Recall Campaign No. 04V476000

Re: Aqua Hot Hydronic Heater Exhaust Termination

Products: 2003 - 2005 Monaco Coach Corporation 40DST Class A Motorhomes with Aqua-Hot Heaters

Recall 04V476000 Aqua-Hot Exhaust

Drawing #1

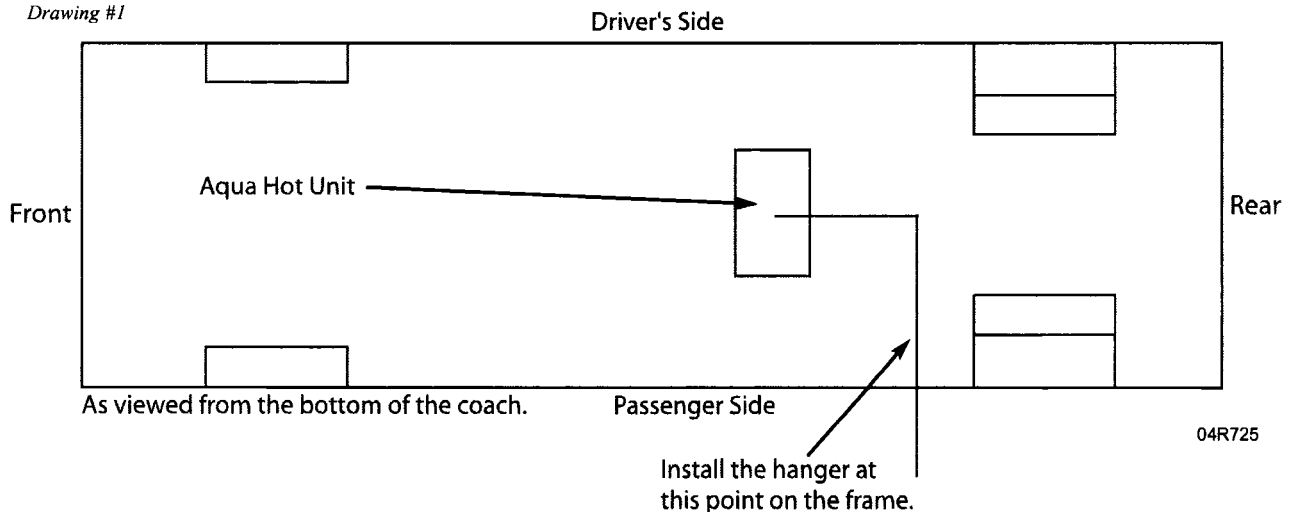
The exhaust termination from the Aqua Hot Hydronic Heater is under the bedroom slide out, when it should be beyond the periphery of the vehicle. This error makes it possible for fumes to enter the coach and possibly allow carbon monoxide fumes to vent into the motorhome, which could result in serious injury or death to the passengers.

1. Reinstall the exhaust pipe with the end terminating on the passenger side (see drawing #1).
2. Install a hanger at the frame edge to support the exhaust pipe.
3. Reinstall the clamp at the elbow, tighten.
4. Trim the pipe so the end is flush or extended beyond the side wall no more that 1.5"
5. Install chrome extension (not to terminate more than 1.5" from sidewall)
